**Planning & Development Division**  
Planning & Economic Development Department

File Number	PL 20-094	Contact	Kyle Deming	
Type	Special Use Permit for a Sanitary Sewer Lift Station	Planning Commission Date		July 14, 2020
Deadline for Action	Application Date	June 15, 2020	60 Days	August 14, 2020
	Date Extension Letter Mailed	July 2, 2020	120 Days	October 13, 2020
Location of Subject	2114 W. Michigan Street			
Applicant	City of Duluth, Public Works and Utilities Department, Engineering Division	Contact	Aaron Soderlund, Project Engineer	
Agent	N/A	Contact	N/A	
Legal Description	Parcel ID 010-1120-00105			
Site Visit Date	July 1, 2020	Sign Notice Date		June 30, 2020
Neighbor Letter Date	July 2, 2020	Number of Letters Sent		17

Applicant is requesting a new sanitary sewer lift station to replace the existing lift station, which will be demolished as part of MnDOT's Twin Ports Interchange Project.

LIFT STATION 15 RELOCATION  
CITY OF DULUTH, MINNESOTA  
2114 W MICHIGAN STREET

FILE NO.  
00616135  
SHEET  
A-1

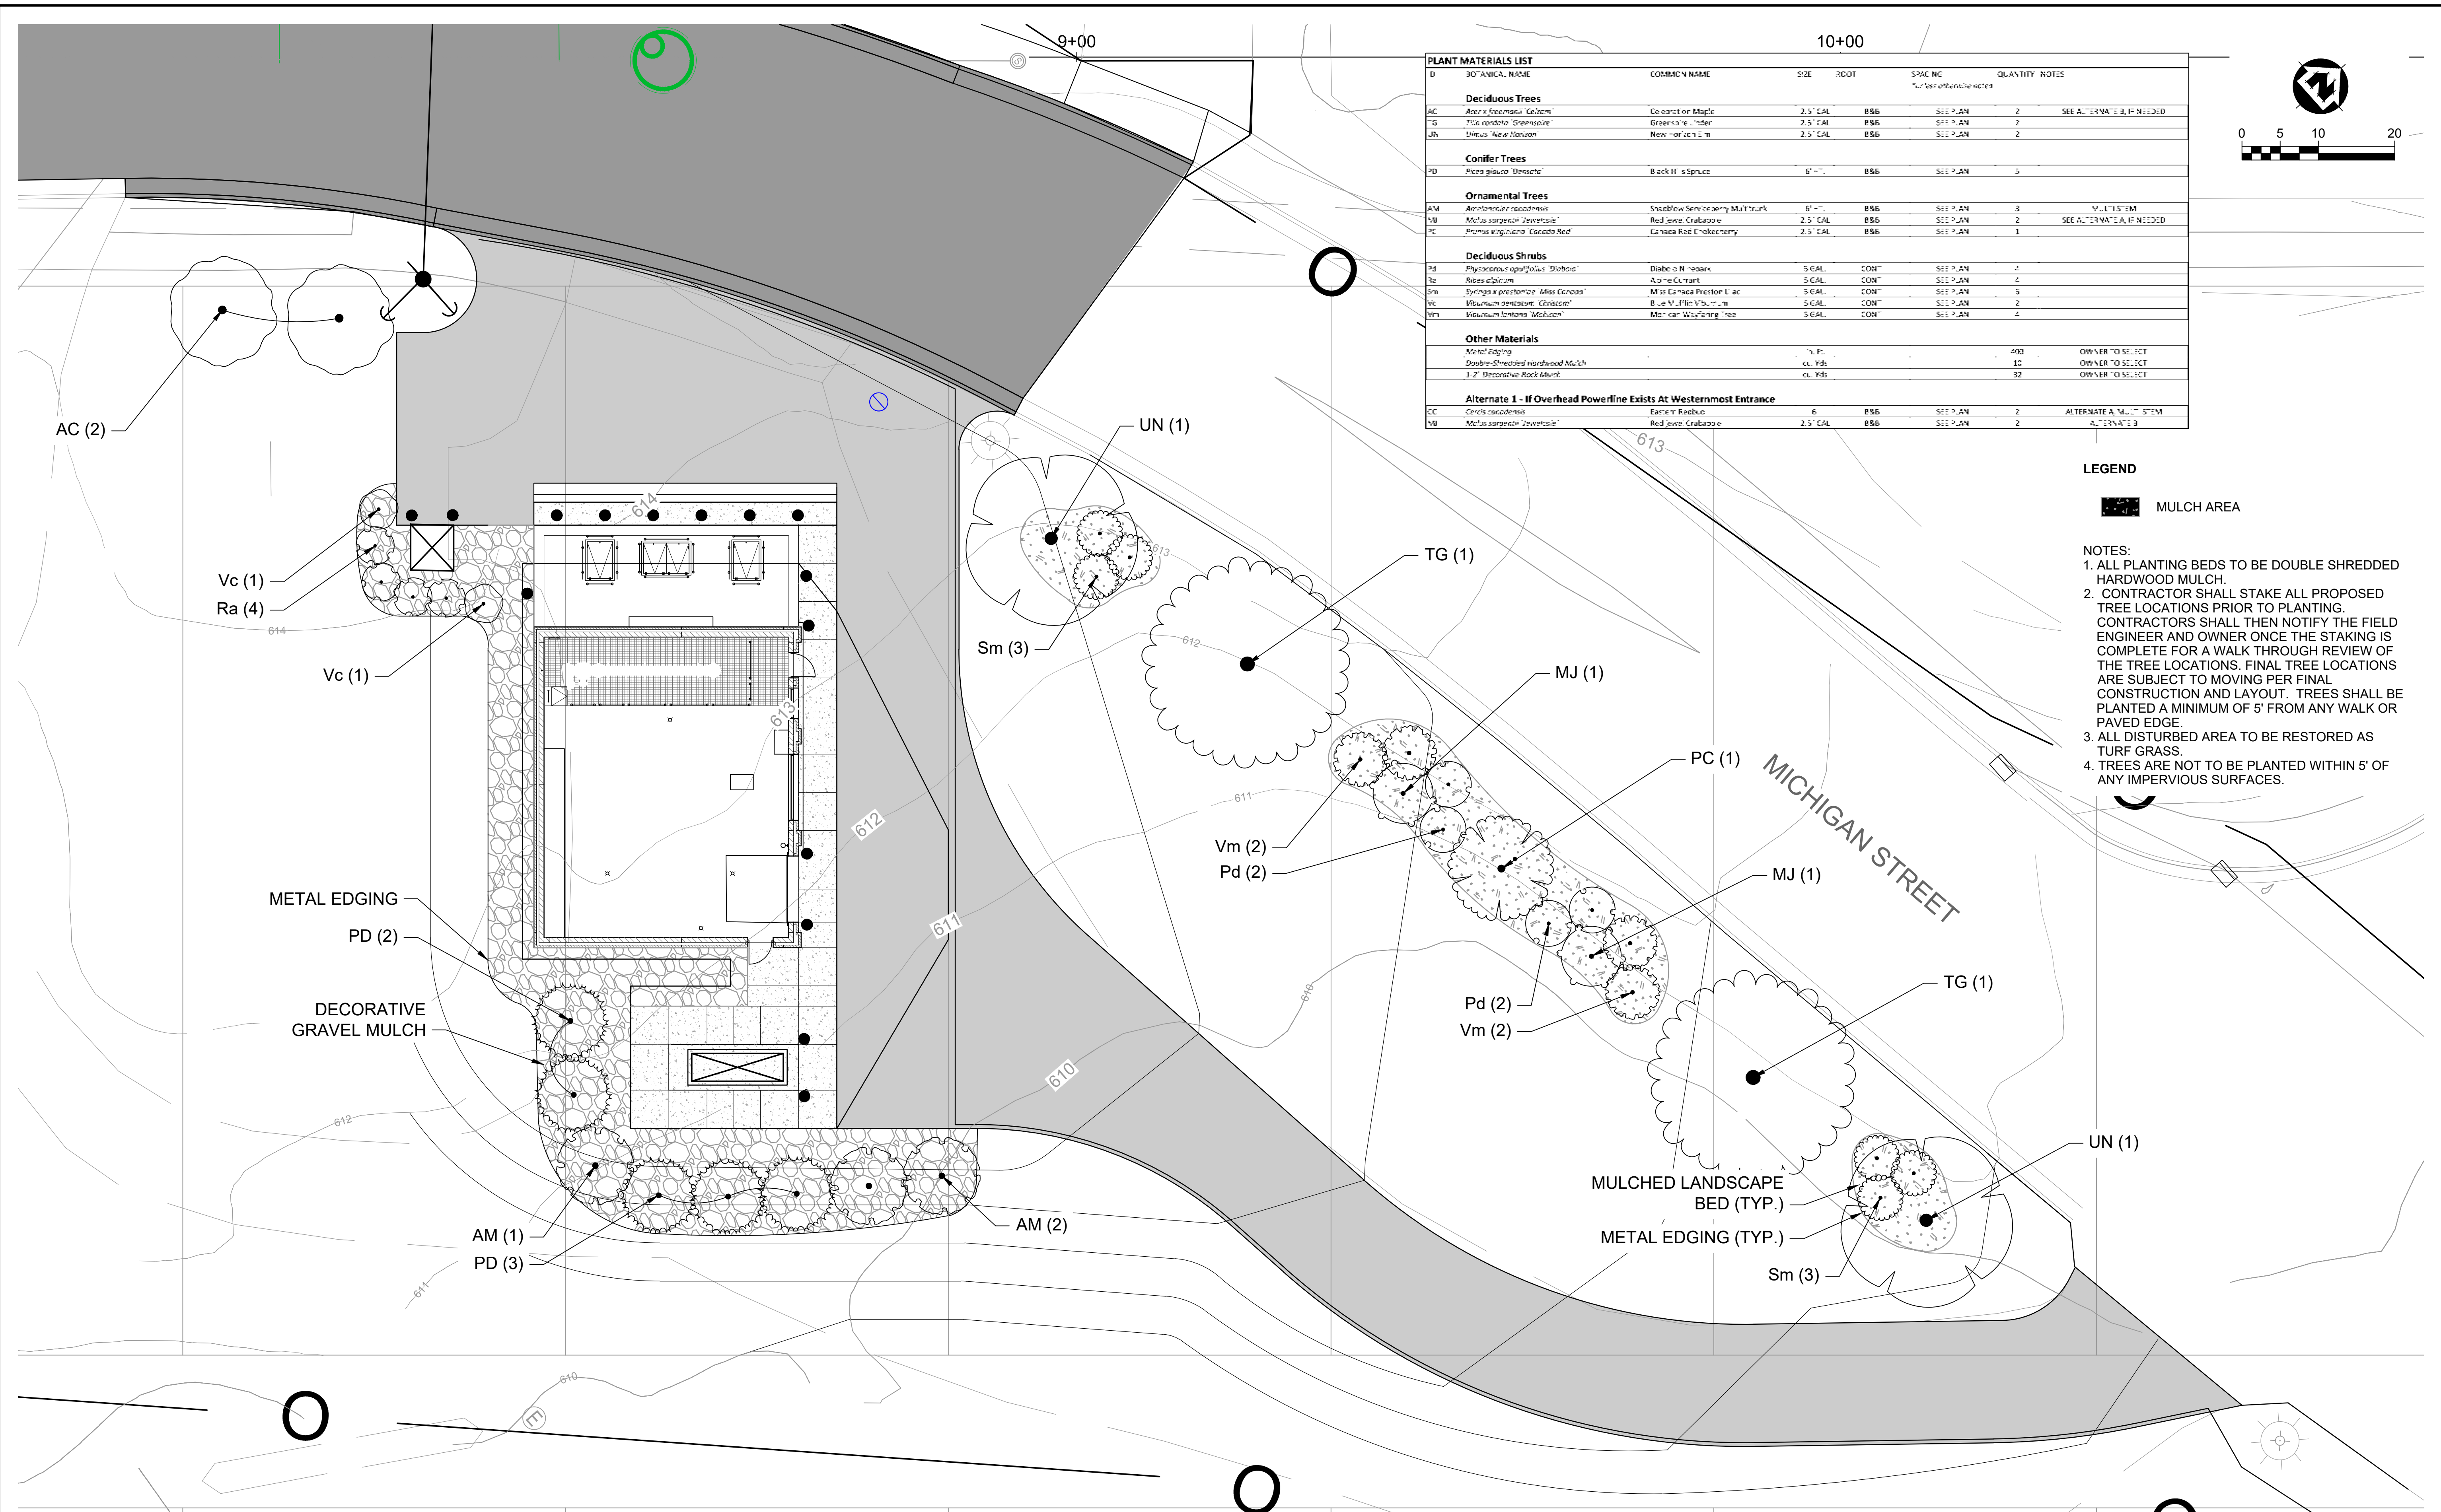
- 10) Sec. 50-29 (Sustainability Standards). Structure is less than 10,000 SF, not applicable.
- 11) Sec. 50-30 (Building Design Standards). Building design complies with applicable Industrial Design standards in Sec. 50-30.4. Façade articulation requirements don't apply due to the length of building walls being shorter than minimum need to incorporate articulation. Entryway design requirements are met by the roof overhang, though emphasizing the entryway is not necessary since this is not a structure open to the public.

- 1) The project be limited to, constructed, and maintained in conformity with the following plans by MSA Professional Services titled "Lift Station 15 Relocation" Sheets A-1 (Perspectives), C-1 (Overall Site Plan), C-3 (Proposed Site Grading Plan), Sheet C-4 (Erosion Control Plan), Sheet C-8 (Pavement Restoration Plan, Sheet L-1 (Proposed Landscape Plan) and Sheet L-2 (Landscape Details); and
- 2) Any alterations to the approved plans that do not alter major elements of the plan may be approved by the Land Use Supervisor without further Planning Commission review; however, no such administrative approval shall constitute a variance from the provisions of Chapter 50.
